RECEIPT DATE: 2/21/19 **ONSITE SEWAGE DISPOSAL SYSTEM** P 564767
 APPROVAL DATE: 5/14/19 **PERMIT: CONSTRUCTION** A _____
 PROPERTY ADDRESS: 13815 Mill Creek Court
 SUBDIVISION: Crawford Subdivision LOT: 22 TAX ID: _____
 CONTRACTOR: South Carroll Backhoe EMAIL: sbackhoe@comcast.com
 CONTRACTOR ADDRESS: 4410 Salem Bottom Road, Westminster, MD 21157 PHONE: 410-596-3618

Hello Kristy everything looks good. However, we have a few minor changes on your OSDS plans. They must be revised and resubmitted for review. Your building permits will not receive building permit approval until the OSDS plans have been approved. I will list them in order of lot.

SITE PLAN FOR BAT INSTALLATION

CRAWFORD SUBDIVISION
LOT 22 (13815 MILL CREEK COURT)
PLAT NO. 24600-24607

1500 Gal Top-Tight Tank
Set up as Hoot pump chamber

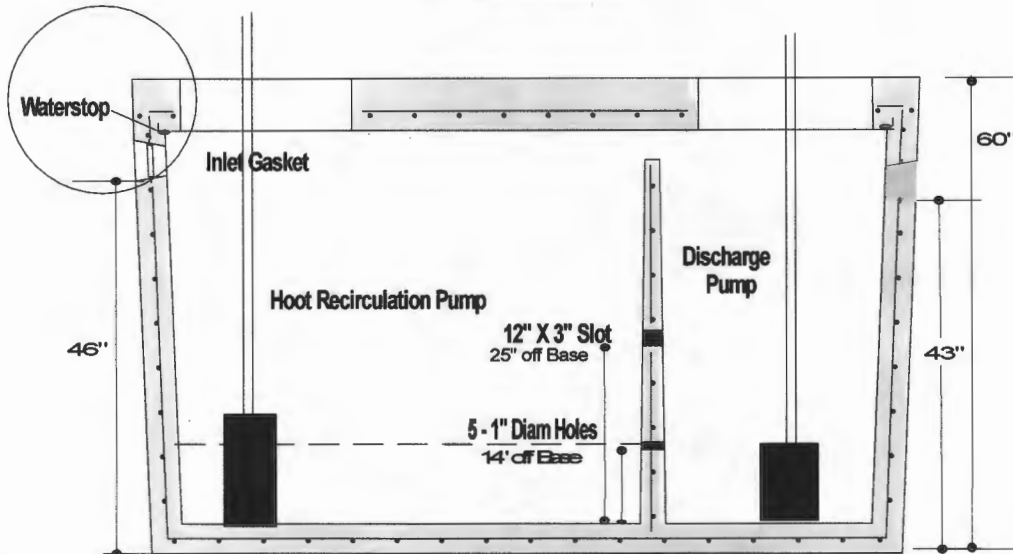
Nancy,
We have reviewed this proposal for the Mill Creek leaking pump tank. Unfortunately we cannot approve this design you have submitted. The 2 compartment setup with the 1" holes in the lower part of it does not give us a better solution. However, if you can submit this to the builders engineer and have them redline the current BAT site plan with this new tank along with their stamped seal of approval, we will accept it.

mastic seam. We used to do this with WSSC grease interceptors and it actually caused more problems than it prevented by "floating the lids" and unsealing what was sealed. The mastic has NO memory and cannot be resealed without completely removing and resealing the lid. We make a new style of tank for high water areas where the top is poured ON the tank and the top cannot be floated off. They are primarily for the WSSC interceptors and the Queen Anne County Sewer extension. I would like to replace the 2 pump chambers going into Mill Creek with these style tanks.

Nancy,
I tried calling you Friday. For the current Mill Creek project, I am a little confused as to the 2 compartment pump tank you are referring to. You say the flow through can be set at 14" are you talking about the slot in the partition? Can you send me an exact drawing of what you are proposing for this project?

Kevin,
I'd
like to turn a problem into an opportunity. It appears we have a problem with a tank out at Millcreek with a leaking pump chamber. Ken from South Carroll said he was told he would have to water test the replacement tank above the
